**Proposal #02: 1071-07-79, WISC2024351**  
**La Crosse – Sparta**  
**(Safety Rest Area 16 Sparta Building)**  
**IH 90**  
**Monroe County**

This is Addendum No. 01, which provides for the following:

**ADDENDUM NO. 01**

**1071-07-79**

Addendum No. 01  
 ID 1071-07-79  
 Revised Sheet 47  
 May 7, 2024

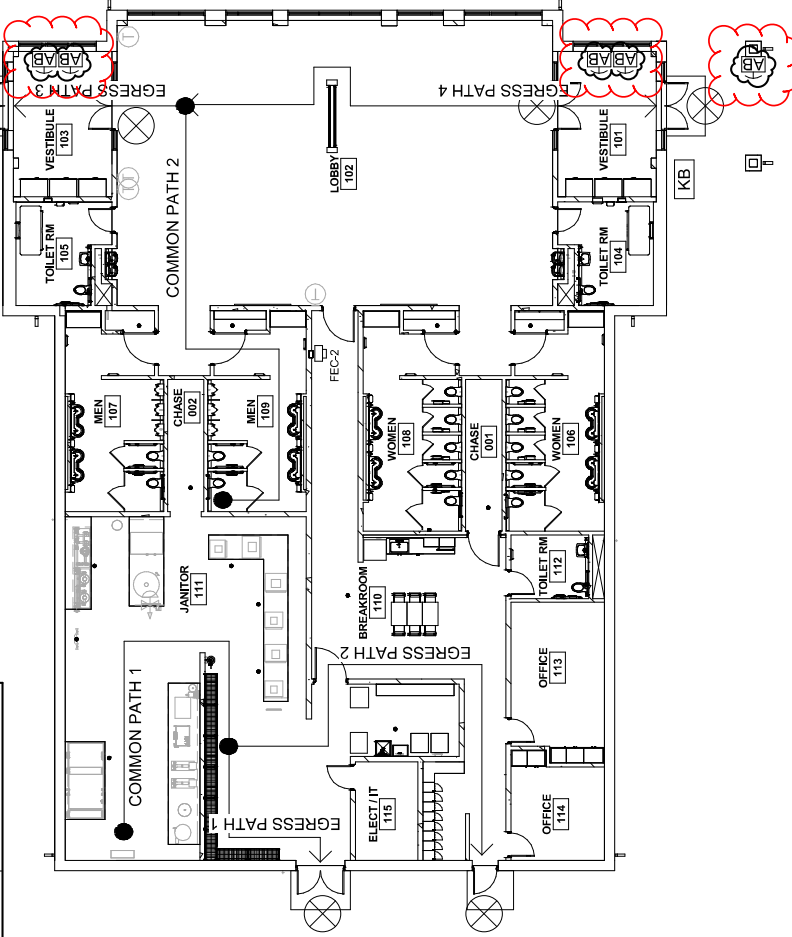
Revised Plan Sheets	
Plan Sheet	Plan Sheet Title (brief description of changes to sheet)
43	Revised Building Architectural Plan (G1-11) – Detail sheet added to sheet index
47	Revised Building Architectural Plan (G1-21) – Added door actuator button to code data plan and floor plan

Addendum No. 01  
 ID 1071-07-79  
 Revised Sheet 71  
 May 7, 2024

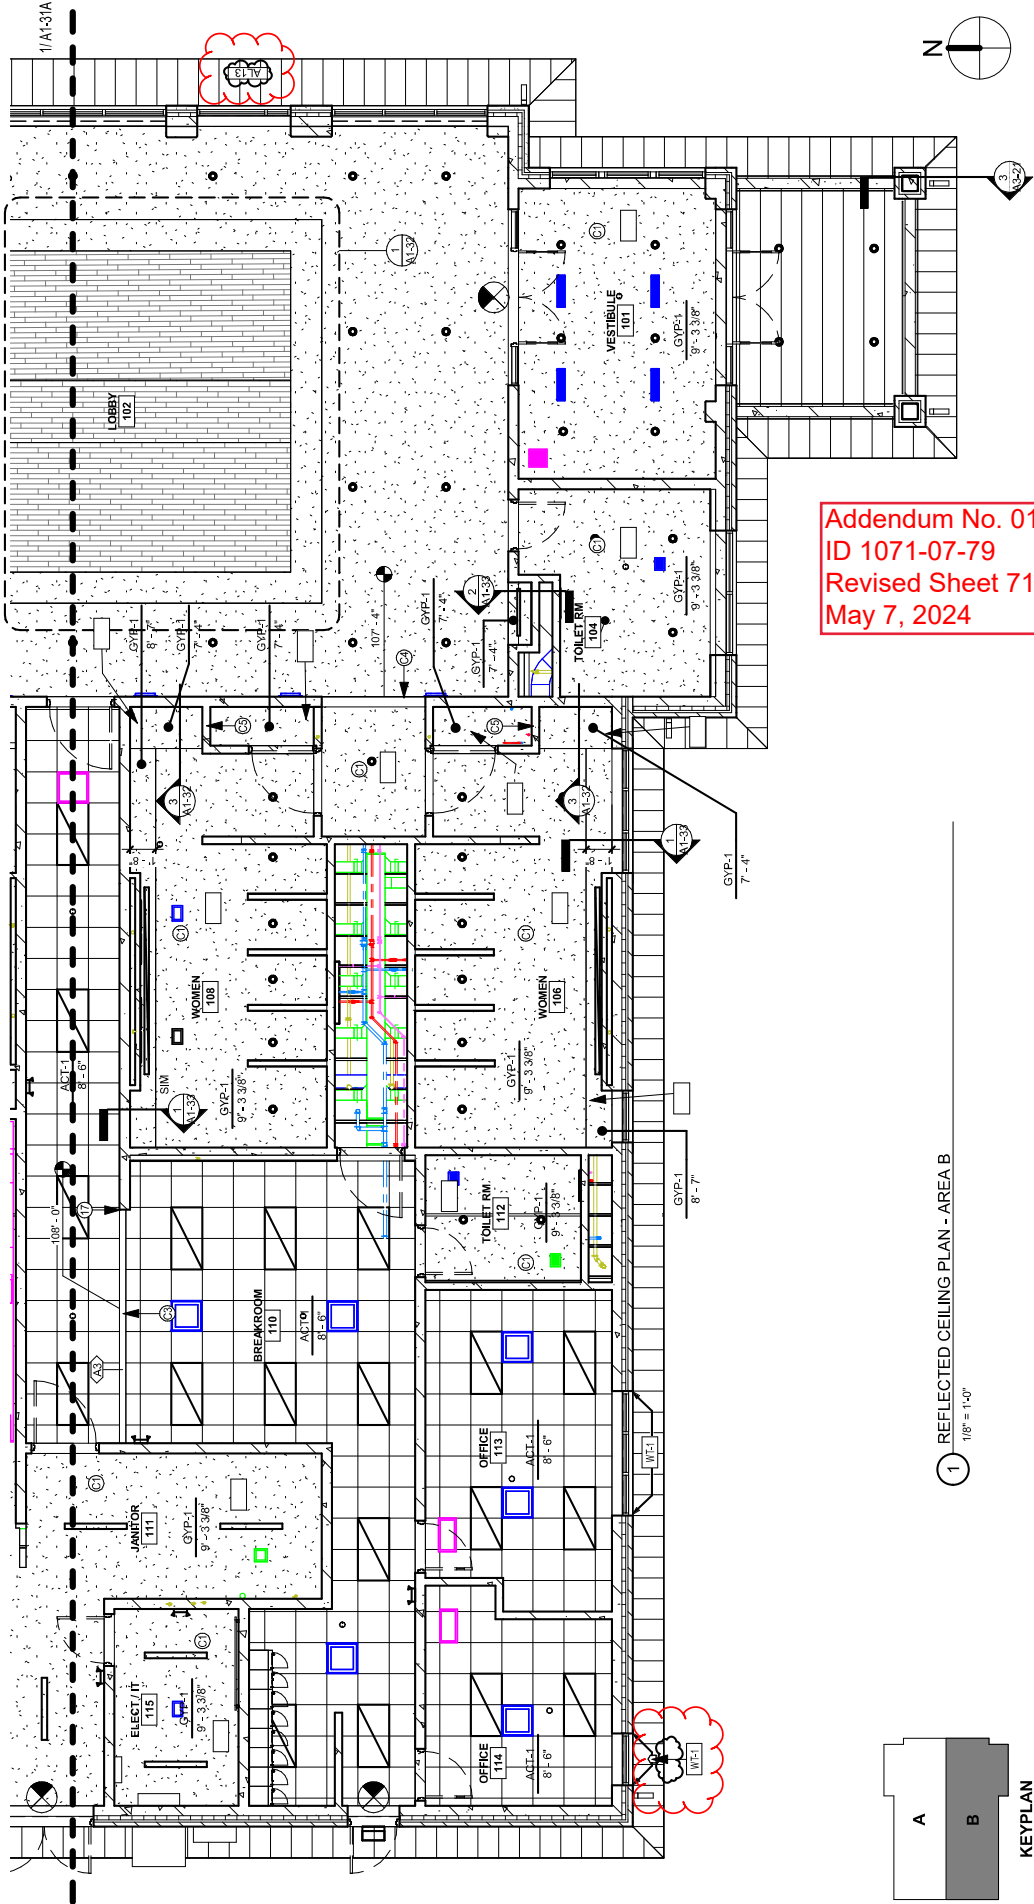
71	Revised Building Architectural Plan (A1-31B) – Clean up tags
82-84	Revised Building Architectural Plan (A2-11 – A2-13) – Revised exterior finish schedule, revised exterior elevation tags, revised exterior elevation names
87-91	Revised Building Architectural Plan (A3-21 – A3-31) – Revised approx. grade, revised detail components, revised visible levels, added insulation, revised wall & base details
94	Revised Building Architectural Plan (A3-34) – Revised detail annotation
99	Revised Building Architectural Plan (A4-11) – Revised door schedule
102-103	Revised Building Architectural Plan (A4-21 – A4-22) – Revised detail annotation at window sills
107-109	Revised Building Architectural Plan (A5-11 – A5-13) – Revised spelling
195	Revised Building Architectural Plan (E2-00) – Update keynote #46. Add (2) well pump and (1) sewage ejector pump locations on plan.
201	Revised Building Architectural Plan (E4-11) – Update electrical riser to have contractor refer to SPV 0060.19 for electrical service requirements.
